BOARD OF ZONING APPEALS DIVISION I

**Case Number:** 2025-DV1-064

**Property Address:** 3155 Arbor Street (*approximate address*)

**Request:** Variance of Development Standards of the Consolidated Zoning and Subdivision Ordinance to allow for a detached accessory garage within the front yard of Arbor Street (accessory structures must be behind primary buildings), and for a 72-foot wide parking area within the front yard of Arbor Street (maximum 30-foot wide parking area permitted).

**2025DV1064 ; Site Plan**

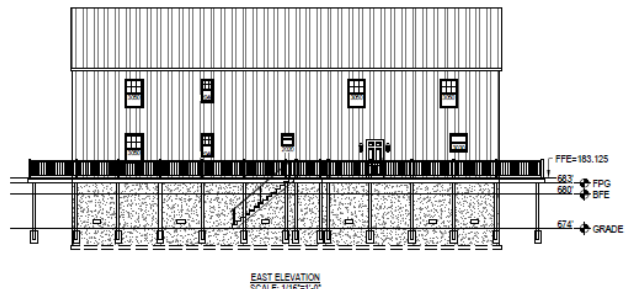
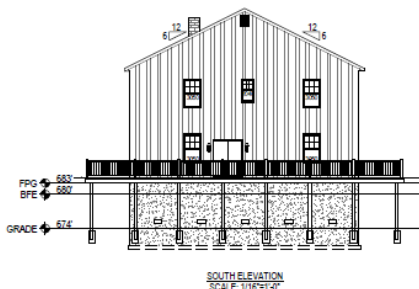
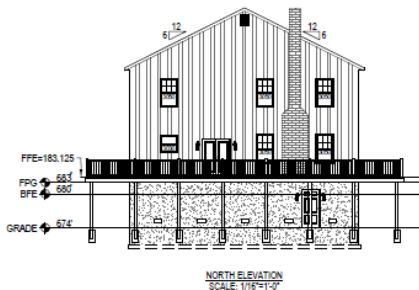
- Due to site-specific constraints related to the location of the property within the Floodway Fringe and the limited amount of undisturbed soil at the site, the proposed location of the primary structure at the rear of the site would be the only feasible location for development to occur. Staff would note that in addition to there being no feasible way to have an accessory structure placed behind the primary building, the proposed detached garage would be offset to the north from the primary residence in a manner that wouldn't directly impede visual access from Arbor Street (approximating the intent of Infill Housing Guidelines). For these reasons, staff recommends approval of the requested variance for an accessory structure within the front yard.

- However, no such site-specific practical difficulty exists to justify approval of the requested variance for the parking area width of 72 feet. The limitation on front-yard parking area width for residential areas within the Ordinance exists to allow for vibrant front-yard areas primarily defined by green space (echoed within the Environmentally Sensitive overlay guidance from the Comprehensive Plan) while still allowing adequate space for vehicle maneuverability. Placement of a parking area over twice the maximum amount allowed would run counter to these goals, and may also negatively impact the property within floodway fringe by reducing space for front-yard compensatory storage and drainage retention and resulting in additional areas of mud and chuckholes for the gravel drive. Staff recommends denial of the driveway width variance.

**Staff Recommendations:** Staff recommends **approval** of the accessory garage request and **denial** of the parking area width request.
